PRELIMINARY AND FINAL DRAINAGE PLAN AND REPORT

FALCON STORAGE SUBDIVISION

EL PASO COUNTY

February 4, 2021

SHT. NAME
DRAINAGE PLAN
SHT. NO.
1 OF 1

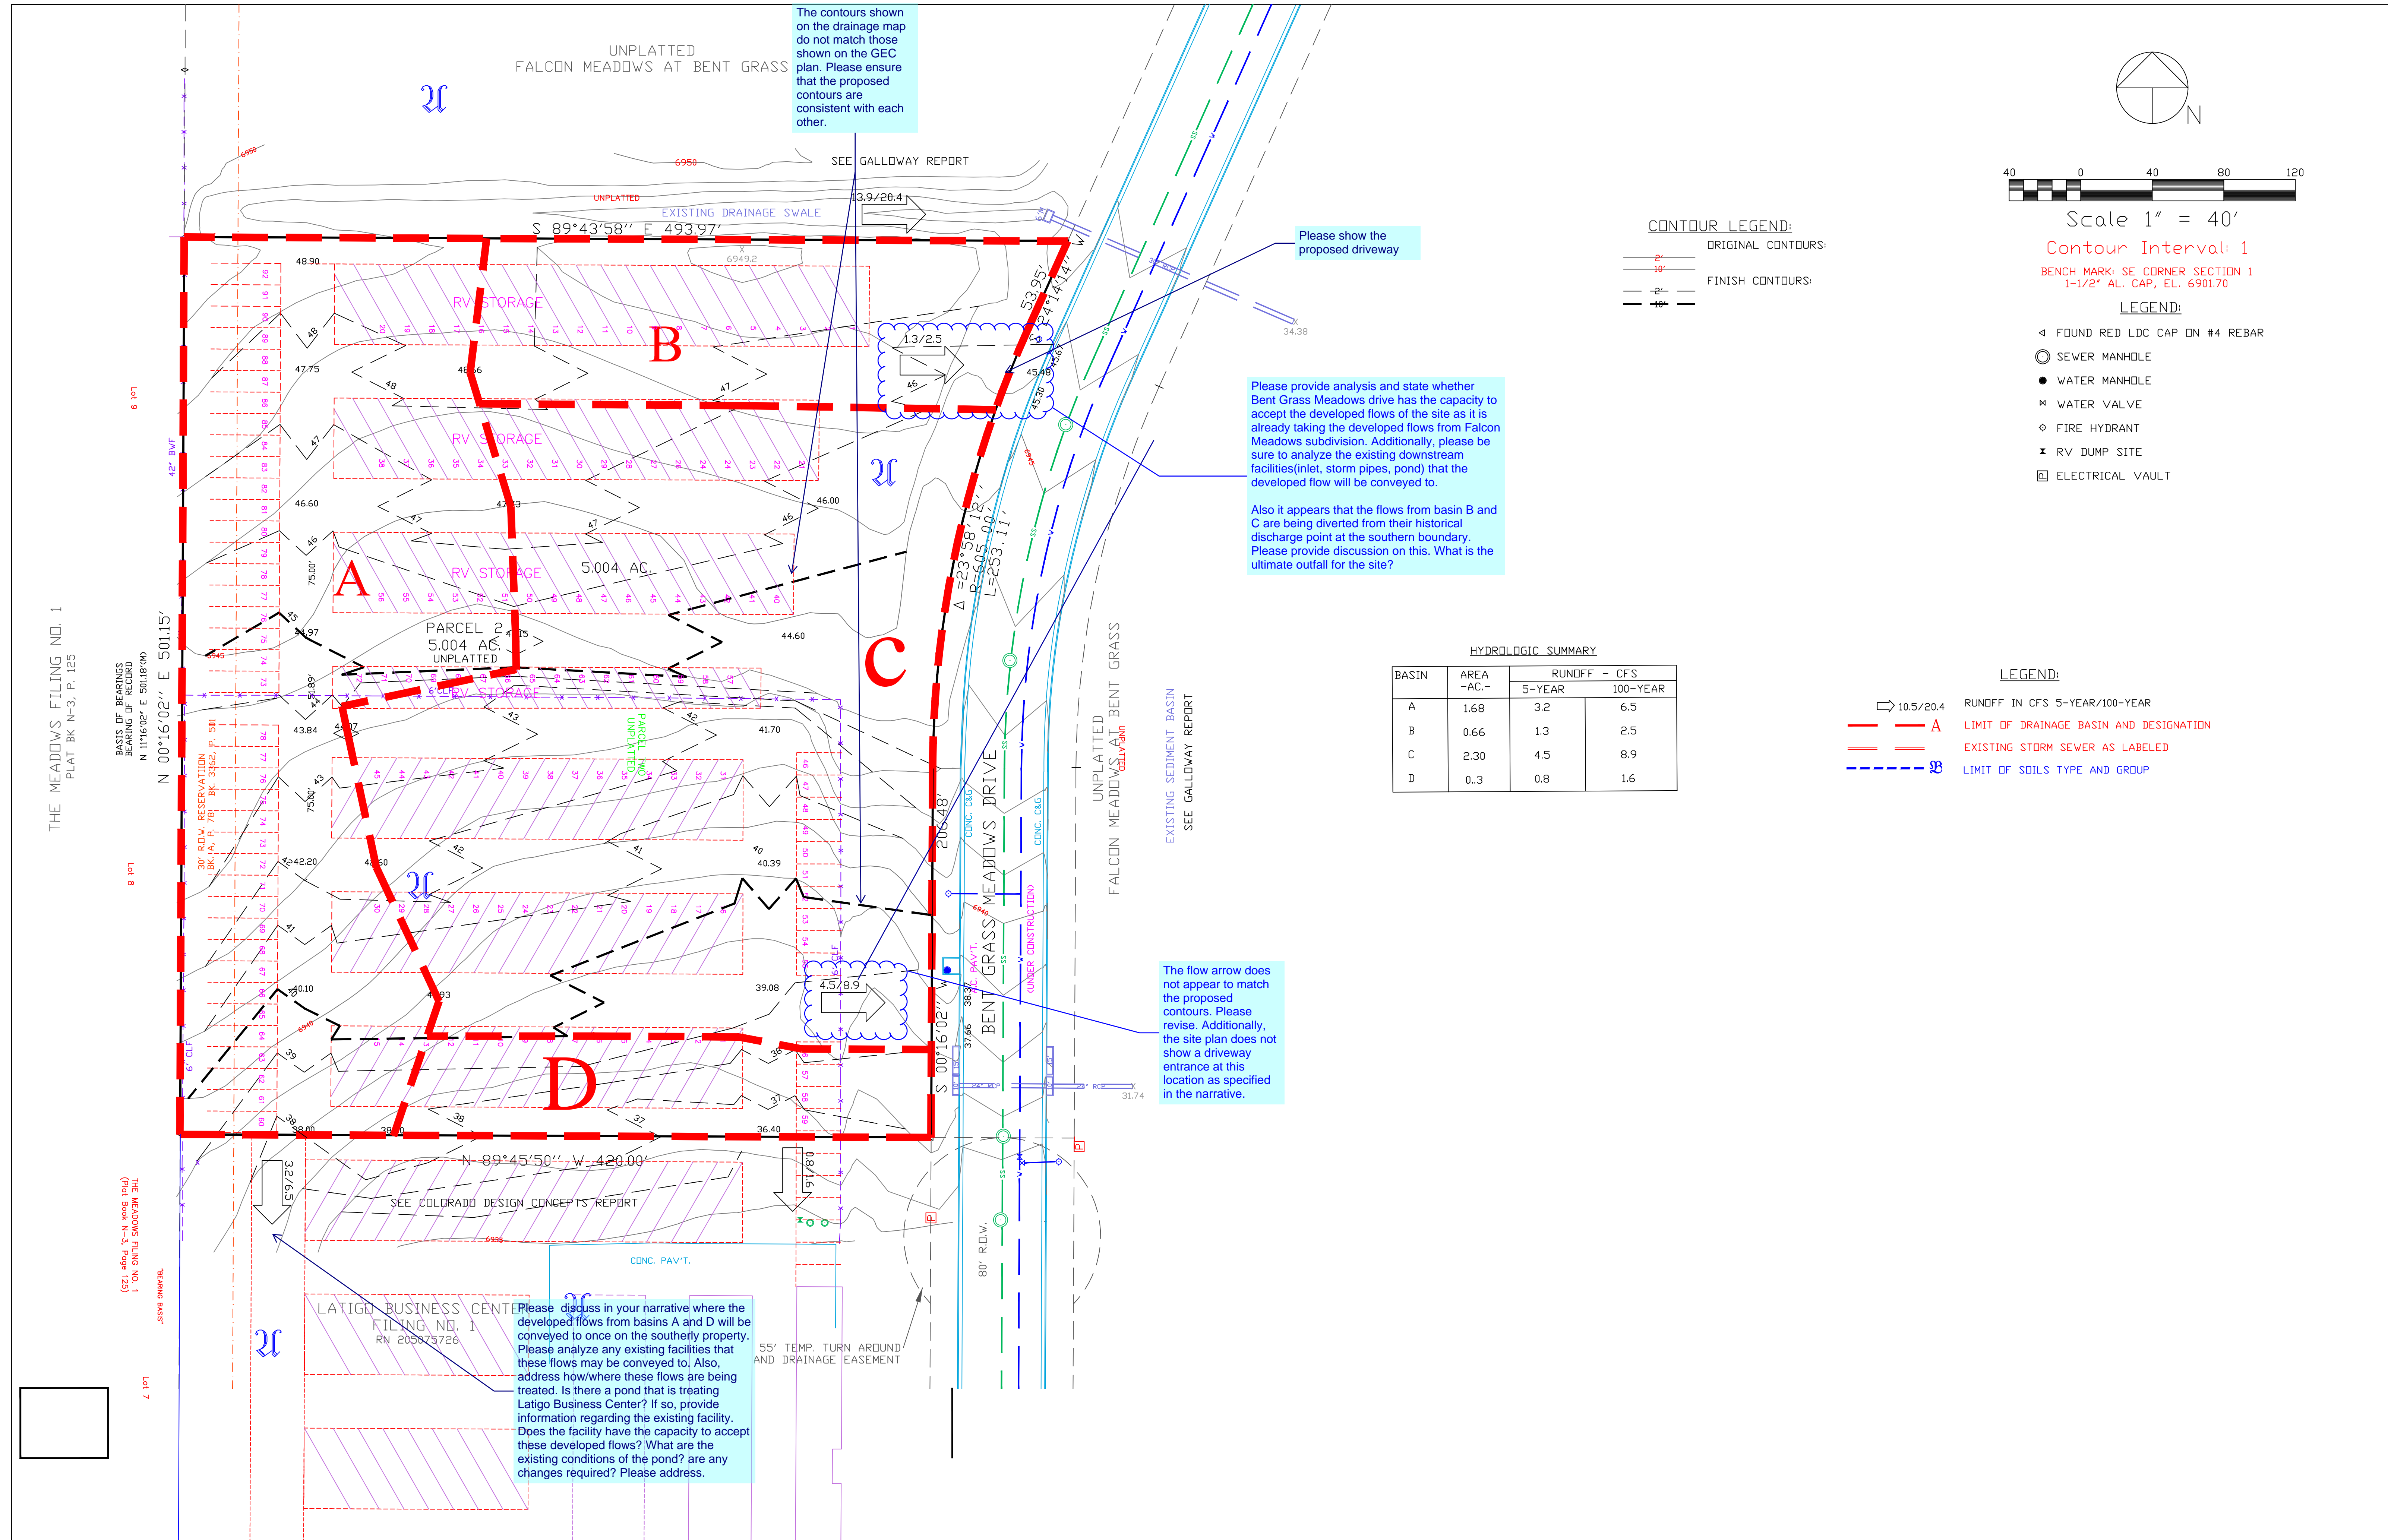
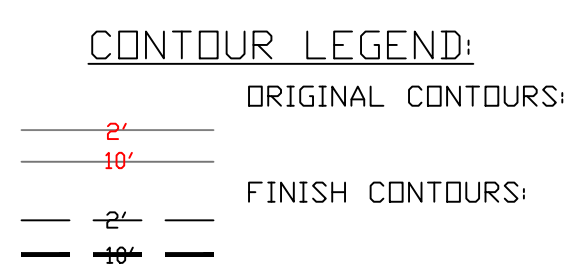
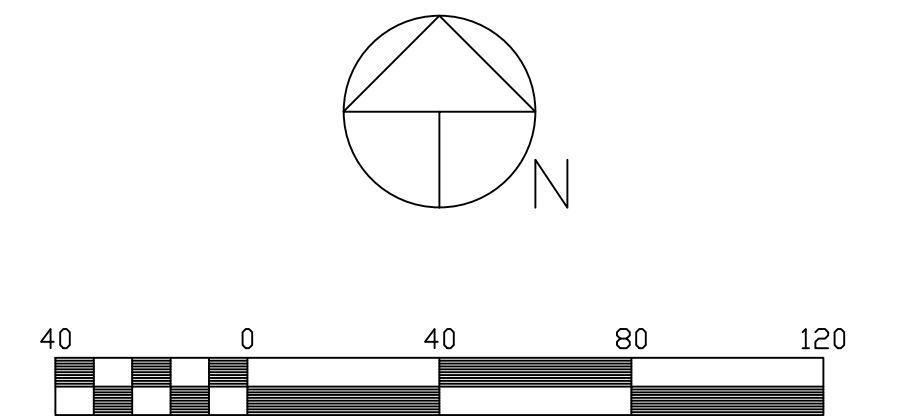
The contours shown on the drainage map do not match those shown on the GEC plan. Please ensure that the proposed contours are consistent with each other.

Please show the proposed driveway

Please provide analysis and state whether Bent Grass Meadows drive has the capacity to accept the developed flows of the site as it is already taking the developed flows from Falcon Meadows subdivision. Additionally, please be sure to analyze the existing downstream facilities (inlet, storm pipes, pond) that the developed flow will be conveyed to.

Also it appears that the flows from basin B and C are being diverted from their historical discharge point at the southern boundary. Please provide discussion on this. What is the ultimate outfall for the site?

The flow arrow does not appear to match the proposed contours. Please revise. Additionally, the site plan does not show a driveway entrance at this location as specified in the narrative.

Please discuss in your narrative where the developed flows from basins A and D will be conveyed to once on the southerly property. Please analyze any existing facilities that these flows may be conveyed to. Also, address how/where these flows are being treated. Is there a pond that is treating Latigo Business Center? If so, provide information regarding the existing facility. Does the facility have the capacity to accept these developed flows? What are the existing conditions of the pond? are any changes required? Please address.
